5-11-12 Figure One

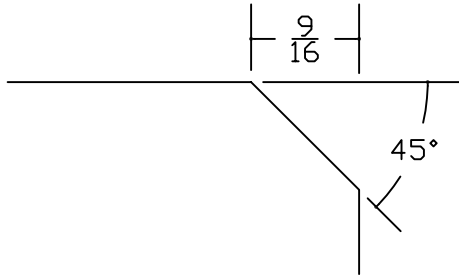
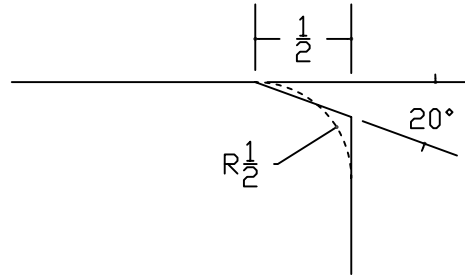
Allowed by IBC and IRC

Allowed by NFPA 101

Allowed by Proposed Change 5-11-12

As angle of bevel increases the encroachment on the tread decreases and increases the flat surface of the tread due to the limit imposed by the 1/2 inch radius.
